**ITEM FOR ENVIRONMENTAL COMMISSION AGENDA**

**NAME & NUMBER OF PROJECT:** Applied Materials Logistics Service Center  
SP-2020-0321C

**REQUEST:** Variance request is as follows:  
Request to vary from LDC 25-8-341 to allow cut to 12 feet.

Project Name: Applied Materials Logistics Service Center  
Ordinance Standard: Watershed Protection Ordinance  
Variance Request: Vary from LDC 25-8-341 to allow cut to 12 feet

# GRADING EXHIBIT

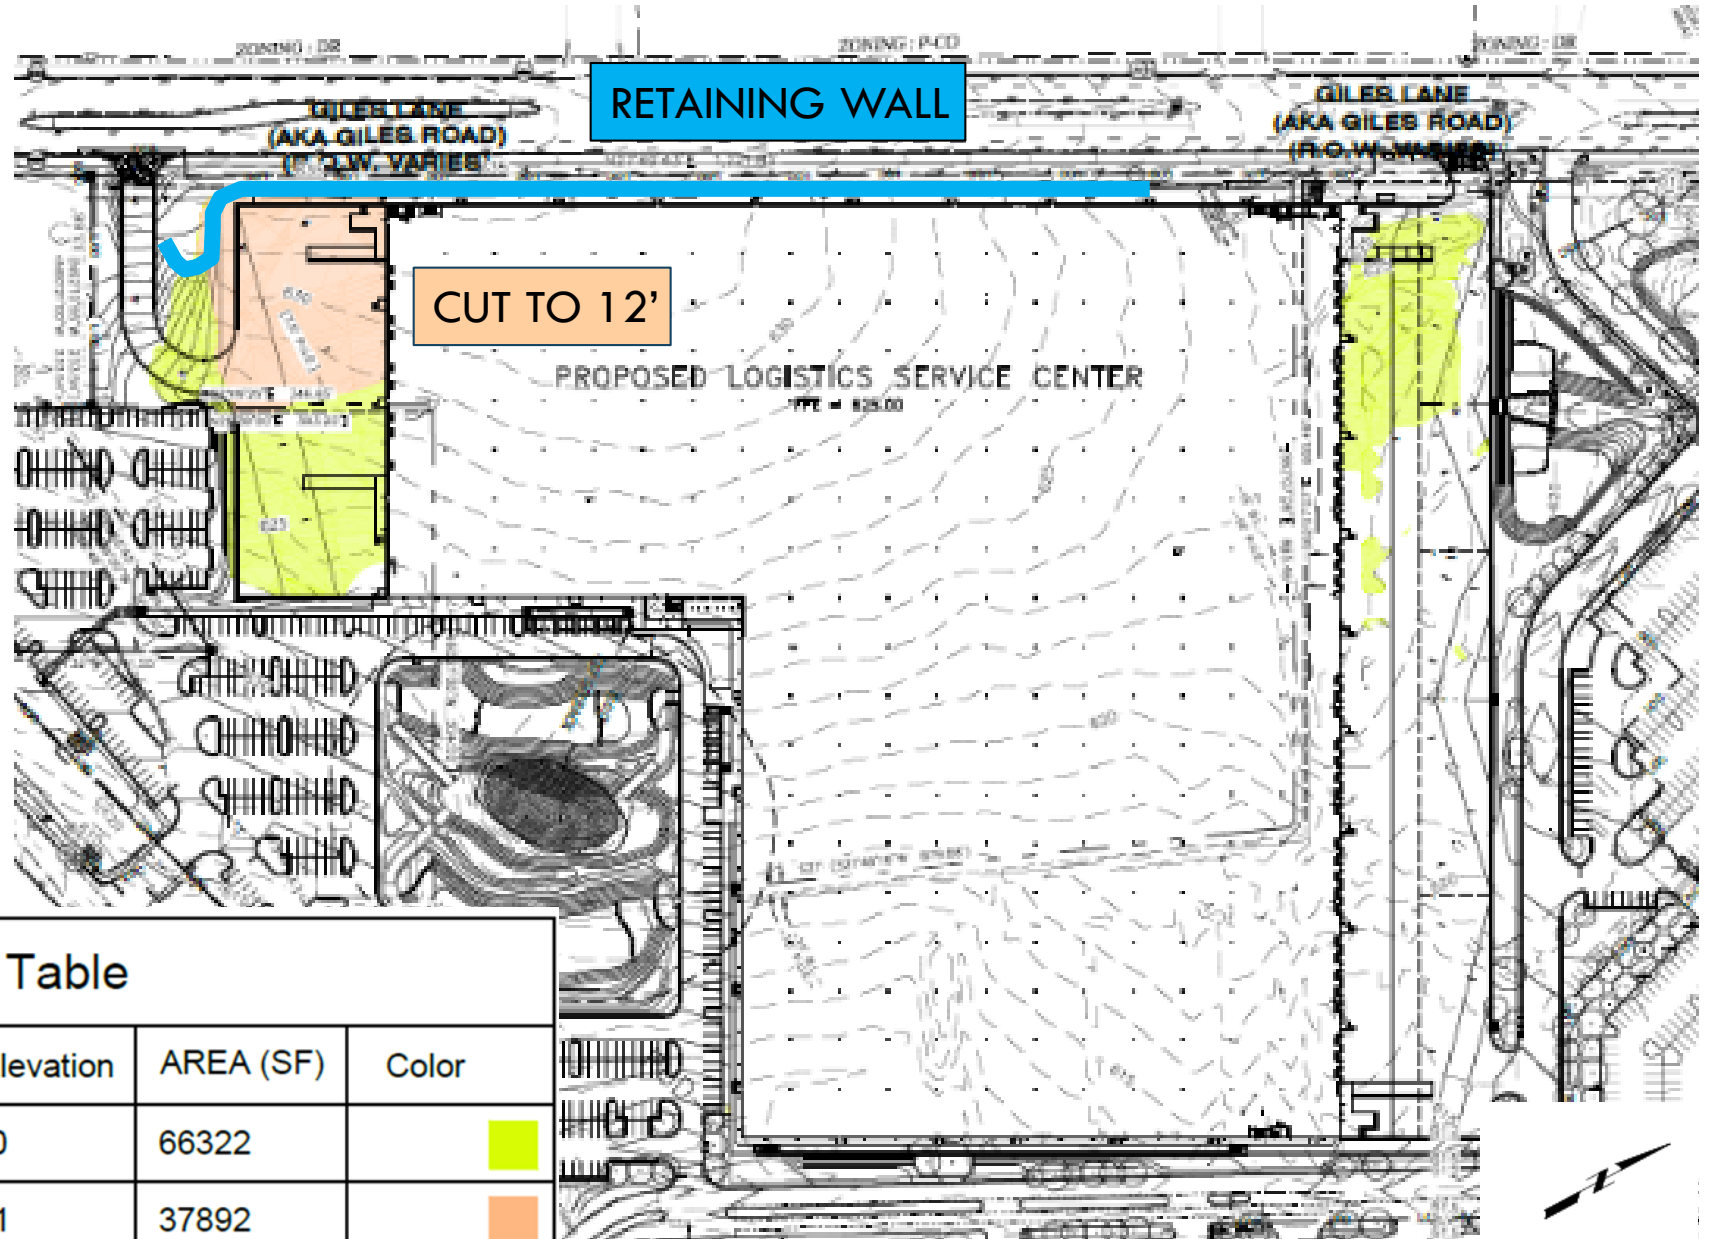
Yes The applicant intends to combine multiple warehouses into one consolidated warehouse at this location. Automated robotic equipment and human operated wheeled equipment to be used in the facility require a consistent floor elevation. The applicant proposes 699,000 square feet of warehouse space with a consistent floor elevation, as well as loading docks, fire lanes, and parking that will be constructed at elevations appropriate for the warehouse finished floor elevation. A consistent floor elevation is necessary for this type of automated warehouse. The applicant proposes to construct this facility on a site with minimal slopes (2% to 5%). However, the size of the warehouse necessitates cut up to 12 feet to achieve a consistent finished floor elevation. The applicant proposes cut up to 12 feet, which has been minimized by use of a retaining wall, as shown in Exhibit 1.

Cut to 12 feet is necessary in the south truck bay to maintain a standard 4-foot dock height.

Yes A retaining wall on the west side, parallel to Giles Lane, minimizes the extent of cut adjacent to the building. The truck court grades slope with the natural contours as much as possible while maintaining minimal slopes to facilitate the maneuverability and circulation of the truck traffic. The applicant has selected a relatively flat site for the proposed warehouse, helping to minimize the required grading.

**STAFF RECOMMENDATION:** Staff recommends this variance, having determined the findings of fact to have been met.

**STAFF CONDITION:** Applicant will stockpile and preserve topsoil for reuse in landscape, wetland mitigation, and/or biofiltration areas.
